Section 73 application to vary conditions (27) and (28) of planning permission TW/10/4051 to allow alternative floodlighting specification to floodlit MUGA on Site 1 at The Skinners Kent Academy, Tunbridge Wells – TW/12/1694 (KCC/TW/0192/2012)

A report by Head of Planning Applications Group to Planning Applications Committee on 24 July 2012.

Recommendation: Planning permission be granted subject to conditions.

Site 1 - Proposed (i.e. as built) Floodlighting Plan

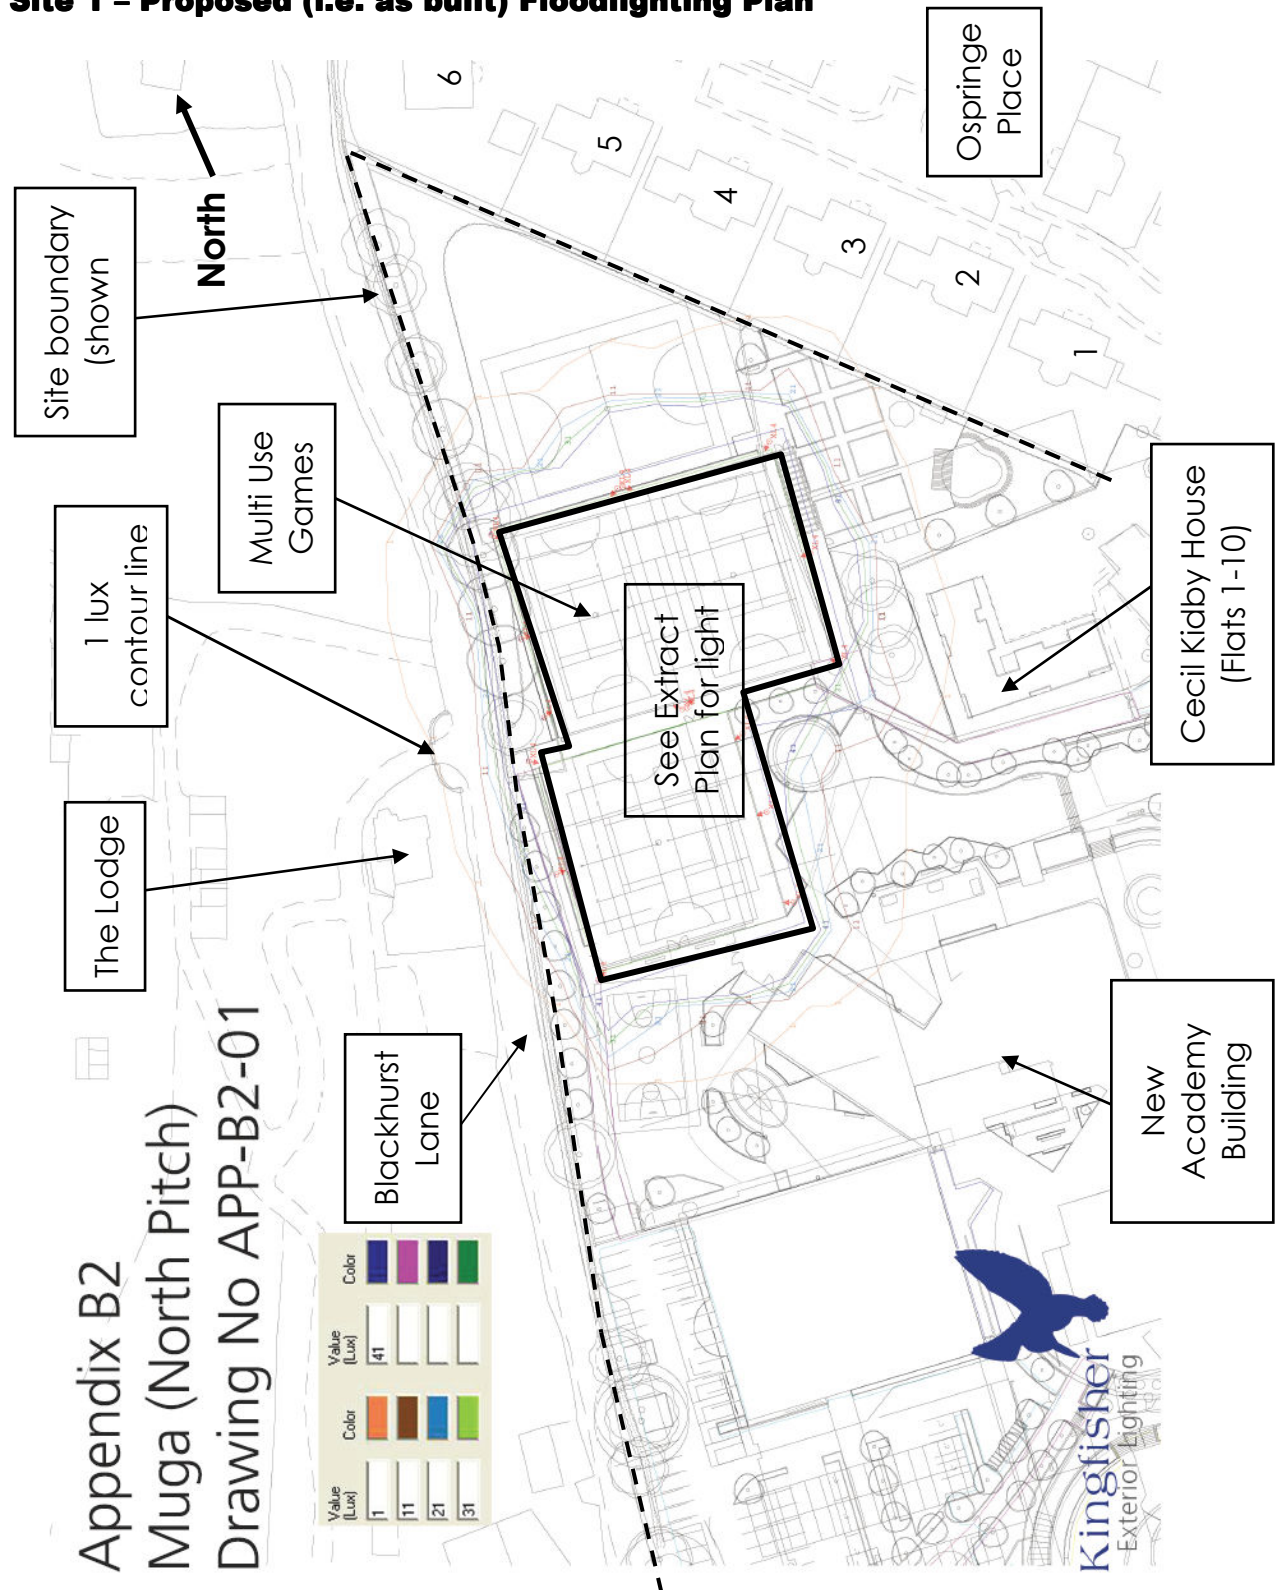
14. The application details that the lighting specification and output of the installed floodlighting differs slightly from the detail that was approved by the main Academy redevelopment consent in the following ways:

- a. the original lighting specification approved showed the lighting columns located within the court. This presented a safety issue for users and a maintenance issue in terms of the potential for damage whilst the courts are in use. It is a standard requirement that no luminaires should be positioned over the principal area for tennis and for netball above a 4 metre diameter circle around the baskets. The lighting columns have therefore been located outside of the courts rather than within;

glare from players. The approved SILL fittings have been replaced with Kingfisher fittings because they meet these criteria but distribute light more evenly than the SILL fittings. The Kingfisher fittings have similar properties to the SILL fittings and comparable output with more even light distribution characteristics and indeed have been successfully used in other floodlit sports facilities at Kent schools. Technical information supplied with the planning application shows that whilst the two light fittings are not exactly the same, the two fittings are very similar;

- c. the combination of moving the columns outside of the courts and the installation of the Kingfisher light fittings (as opposed to approved SILL fittings) means that the resultant lux levels on the courts is inevitably different to the originally approved details. The original details indicated that lighting would present a maximum of 300 lux average across the MUGA court (within the perimeter fencing), whilst the “as-installed” lighting presents a maximum average of 276 lux taking into account maintenance and depreciation factors in the same way as the originally approved details did. The overall change in light spill levels (beyond the edge of the MUGA perimeter fencing) result in a 1 lux spill level extending further northwards across Blackhurst Lane towards The Lodge, and further eastwards towards Cecil Kidby House, and further eastwards towards Ospringe Place with the 1 lux contour dropping off just within the rear garden of No. 3 Ospringe Place and just inside the driveway to The Lodge. Members should note that copies of drawings comparing light spill levels between the lighting scheme previously permitted and that now the subject of this application will be available at the Committee Meeting itself.

He notes that the revised lighting scheme involves changes to the lanterns and reposition of the columns, however considers that this is not significantly different to the original proposal. The relevant British Standard for Sports Lighting recommends average

He notes that in this instance there is an increase in spill light outside the playing areas, however the spill light is reduced to 5 lux part way across Blackhurst Lane (towards The Lodge), 1 lux at the driveway to The Lodge and 1 lux just inside the boundary of the garden of the nearest property in Ospringe Place (No. 3 Ospringe Place). These levels are below the recommended levels set out in the Institute of Lighting Engineers best practice.

Considers that the lighting levels proposed on the playing surface are acceptable, noting that they are actually lower (on average) than those previously approved. Also notes that the source intensity in the direction of adjacent properties is shown to be less than half the recommended limit and in most cases about a third of the maximum value.

He notes that the calculations provided in respect of this application have been carried out assuming no barriers other than the 3 metre high timber acoustic fencing around the MUGAs. However, The Lodge on Blackhurst Lane, which is single storey, has a substantial hedge along the roadside and the front of the house is actually set at right angles to the pitches. On the school side of the road there are also substantial existing trees providing screening. He considers that all of these barriers will lessen the spill and visibility of the lights to a greater or lesser degree depending upon the season.

38. I RECOMMEND that PLANNING PERMISSION BE GRANTED for the alternative floodlighting specification, SUBJECT TO conditions (27) and (28) of planning permission TW/10/4051 being amended to read as follows: -

Condition (27)

The floodlighting associated with the Multi Use Games Area (Site 1) hereby approved shall be maintained at all times as currently set up and as detailed in the application. Should it subsequently be deemed necessary the applicant shall adjust the set up of the floodlighting and/or fit cowls, hoods, shades, shields and/or louvres, in agreement with the County Planning Authority, and thereafter the lighting shall be maintained as agreed;

The illumination and spill levels associated with the Multi Use Games Area (Site 1) shall not exceed those specified within this planning application;

Site 1 - Extract from Proposed (i.e. as built) Floodlighting Plan

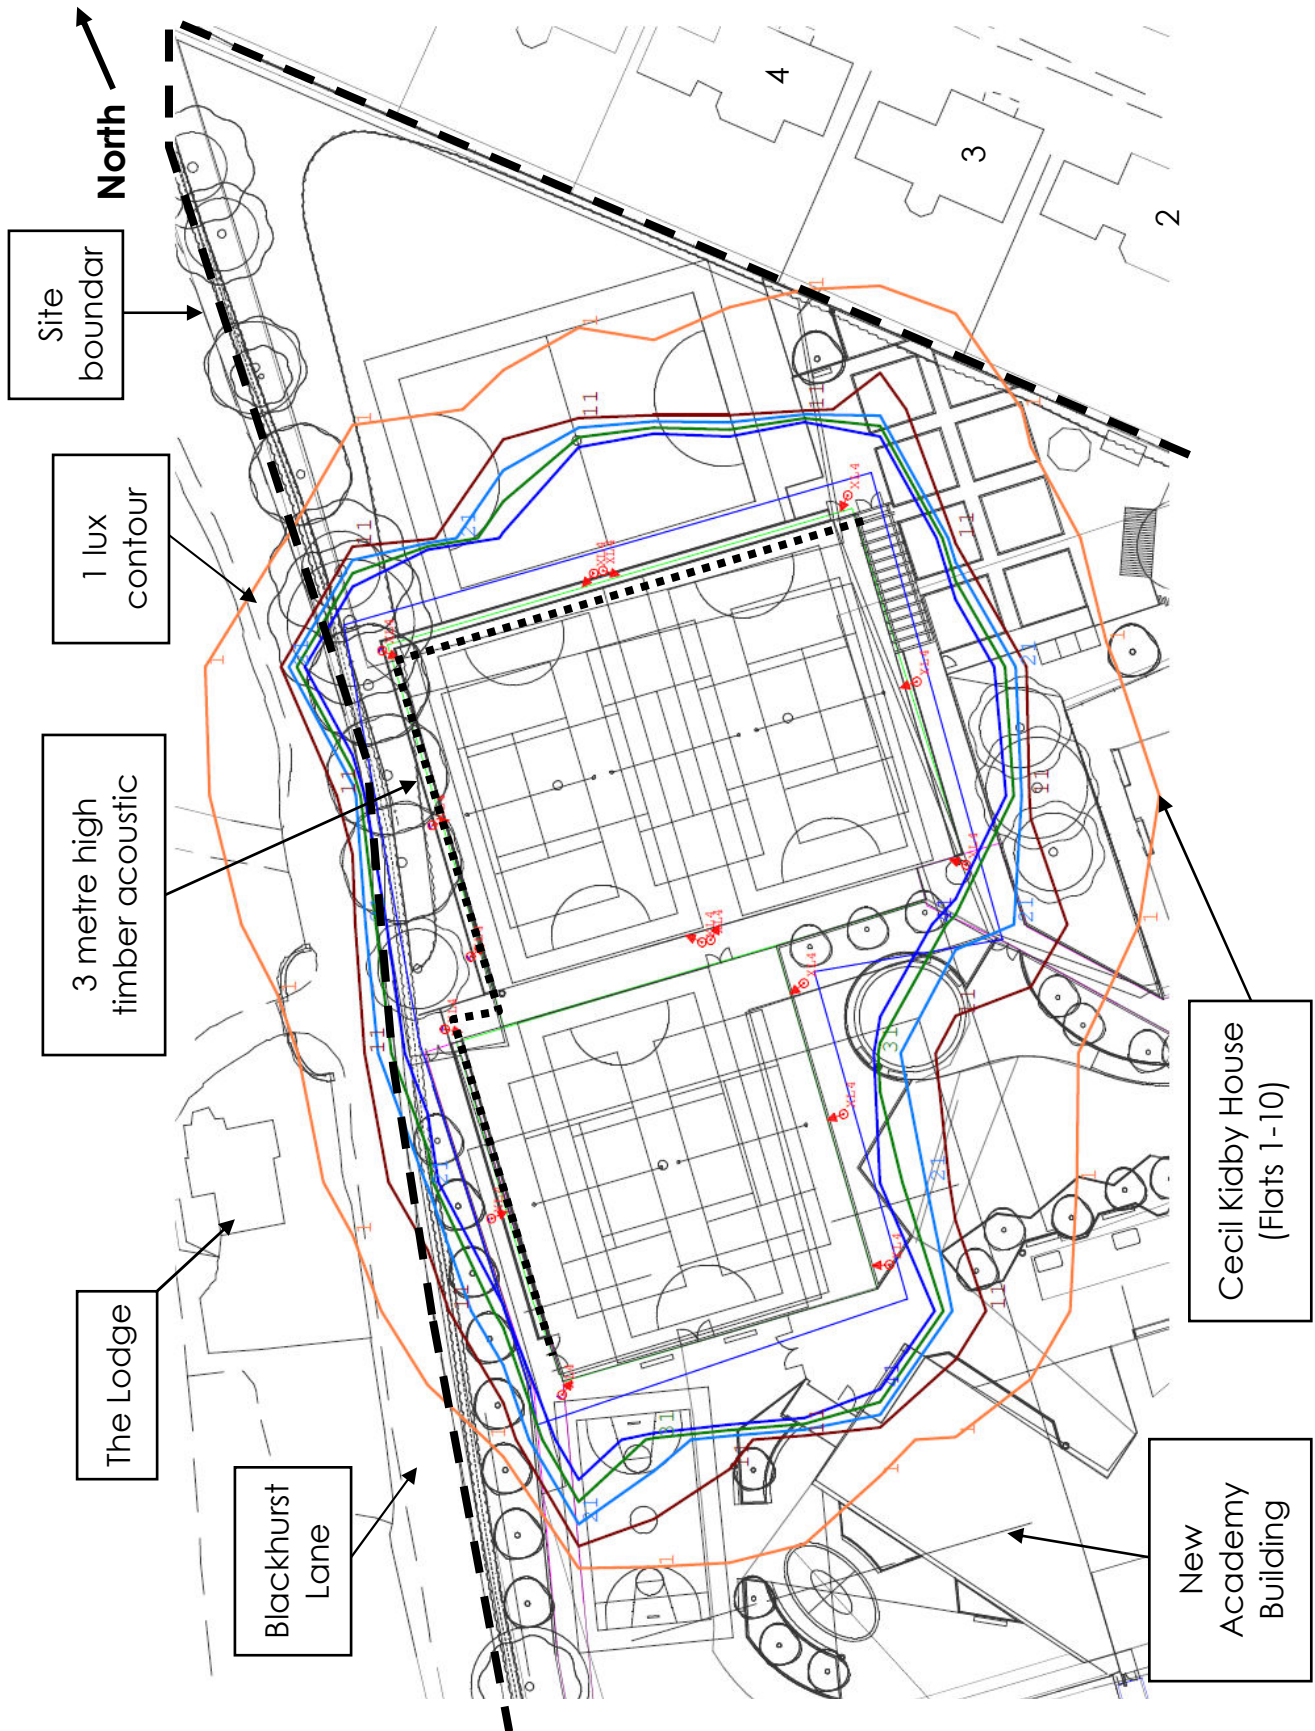
He notes that concerns have been raised regarding the direct view of a couple of floodlights when driving out of The Lodge and considers that additional screening would help minimise this isolated issue.

- the current installation directly opposite the vehicular entrance to The Lodge onto Blackhurst Lane has a cluttering effect when in use at night causing disability glare and impairing vision when manoeuvring a vehicle from the private driveway onto Blackhurst Lane – this has serious road safety implications for vehicles leaving The Lodge or for any pedestrians or motorists on Blackhurst Lane in the vicinity of the floodlights. I am sure that you are aware that it is an offence under the Highways Act to knowingly impair the vision of a motorist.

32. A site visit was undertaken to inspect the current floodlights on Wednesday 4 July 2012 between 22:00 and 23:00 hours, with an officer from Tunbridge Wells Borough Council's Planning Team also being present. That visit proved useful to witness first-hand the impact of the floodlighting in the context of the site's surroundings and nearby sensitive receptors. Photographs taken during that visit will be available for Members to view as part of the Officer introduction to the scheme at the Committee Meeting itself. As part of that visit light spill levels were witnessed between the edge of the MUGA and Ospringe Place, Cecil Kidby House and along Blackhurst Lane (particularly in the vicinity of The Lodge). The concerns raised by the owner of The Lodge in respect of 'glare' issues when exiting his drive were explored during that visit, and it was observed that two lighting units (located in the centre of the largest MUGA some 40 metres away and facing back towards The Lodge) were just visible above the top of the 3 metre high acoustic fencing and between the existing boundary tree screening. It is likely that these two lighting units are those which are resulting in the claimed 'glare' and 'serious highway safety' issues by the owner of The Lodge when exiting his property during night time periods. Having sought advice from my Lighting

39. I FURTHER RECOMMEND that the applicant BE REQUIRED to carry out additional interspersed landscape planting consisting of a couple of heavy standard evergreen trees (at least 3.5 metres high) along the site boundary with Blackhurst Lane. The final specification of this additional tree planting shall be agreed pursuant to the terms of a site wide landscaping scheme under the main Academy redevelopment consent and shall be implemented within the first available planting season following the date of this permission.

Site 1 - Previously approved floodlighting spill levels (as permitted under consent TW/10/4051)

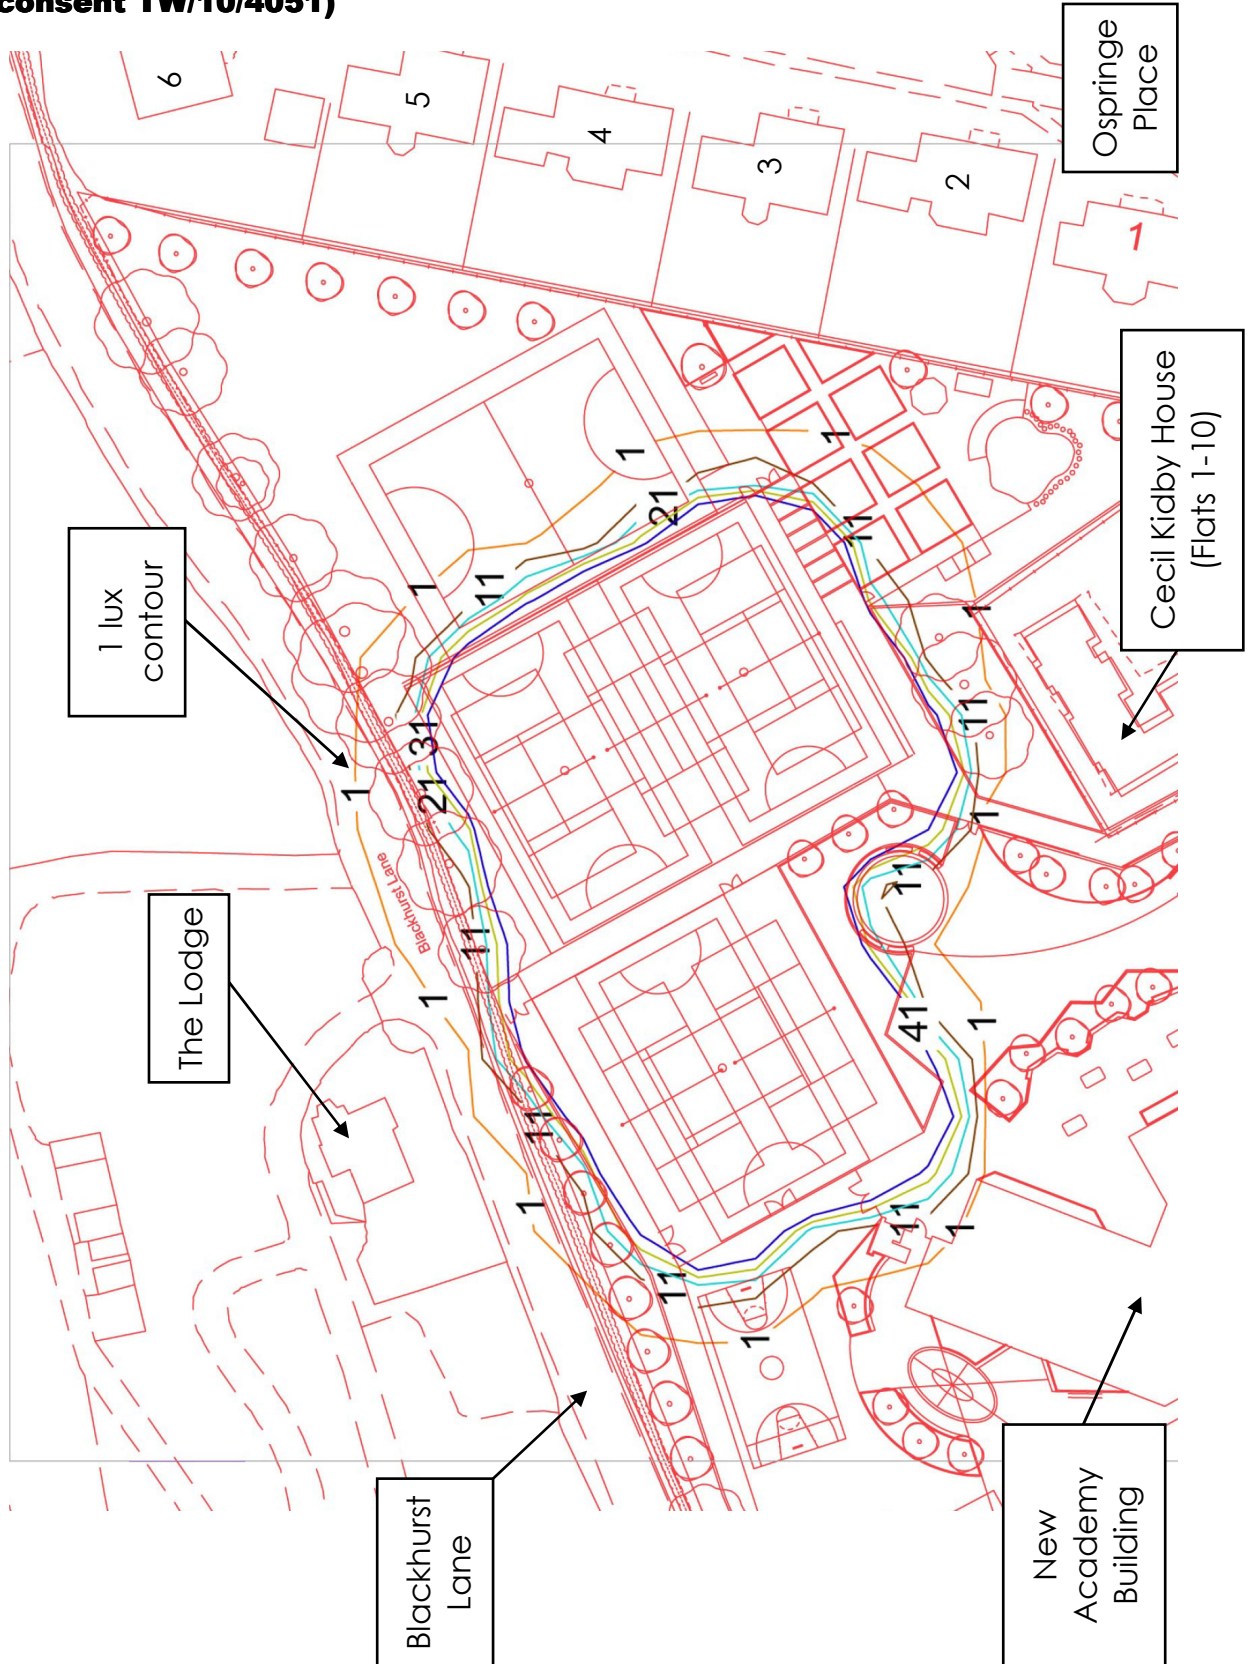
The average lighting levels (as granted permission by the main Academy redevelopment consent) were shown to be 290 lux for the basketball courts and 300 lux for the tennis courts. The currently installed lighting specification is shown to deliver a maintained lighting level of 255 lux to 276 lux, based on actual site readings and applying a maintenance factor of 0.71. He considers that the maintenance factor of 0.71 applied by the applicant is reasonable and is based on the reduction in light output of a lamp through service and the degradation of the lantern output caused by dirt and ageing of reflective materials. He notes that whilst this maintenance factor can change based on lamp cleaning and bulb changing, 0.7 is a typical factor that is commonly applied to sports floodlighting and considers that it would have been the figure applied to the lighting within the original planning application documents.

29. In terms of light spill levels beyond the edge of the MUGA surface (commonly referred to as the 'back-spill' of light) the application recognises that light spill levels are slightly increased towards Blackhurst Lane (and The Lodge) and towards Ospringe Place. To this effect, it should be noted that the 1 lux contour line extends to the driveway of The Lodge, whereas under the approved lighting scheme it only extended to mid-way across Blackhurst Lane. Similarly, the 1 lux contour line extends just inside of the rear garden of No. 3 Ospringe Place whereas under the approved lighting scheme the 1 lux contour fell away mid-way between the MUGA boundary and the rear boundary of properties in Ospringe Place. The application details that 'back-spill' light levels would range between 11 and 1 lux across Blackhurst Lane (moving away from the site boundary) whereas levels previously permitted were typically closer to 1 lux.
